ADDENDUM NO. 3

**HOUSATONIC RIVER GREENWAY BIKE/PEDESTRIAN TRAIL PROJECT
TOWN OF STRATFORD, CONNECTICUT**

**BID #: 2010-004
MMI #:1627-13-5
STATE PROJECT NO. 138-233
FAP NO. PEDS (129)**

**BRIDGING OF UNSUITABLE
 SUBBASE MATERIAL DETAIL**

SHEET:
SK-1

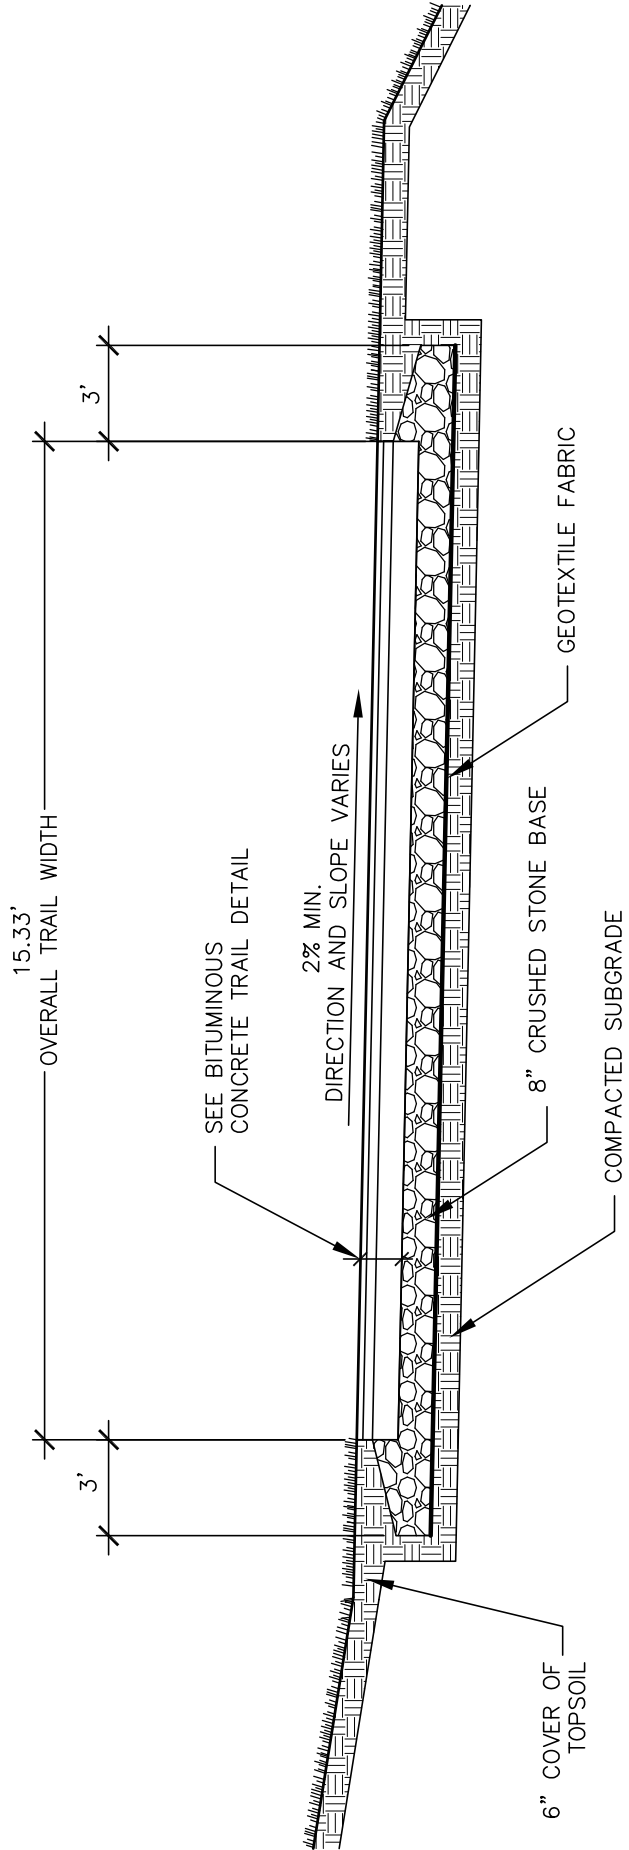
Work under this item shall consist of excavating unsuitable subbase material, placement of geotextile fabric and placement of crushed stone base under paved trail only as shown on SK-1, provided in this addendum, at locations directed by the Engineer.

Crushed Stone shall be placed in prepared trenches to the full depth of the course detailed on SK-1. Material is to be compacted. The completed placement shall be evenly graded and free of clusters of smaller and larger stones.

1. EXCAVATE AND REMOVE UNSUITABLE MATERIAL AND SOIL AS DIRECTED BY THE ENGINEER.
2. PRIOR TO PLACEMENT OF GEOTEXTILE FABRIC CONTRACTOR TO ESTABLISH A SMOOTH GRADE OF THE EXISTING SUBGRADE. PLACE GEOTEXTILE FABRIC ON SUBGRADE - 18' WIDTH
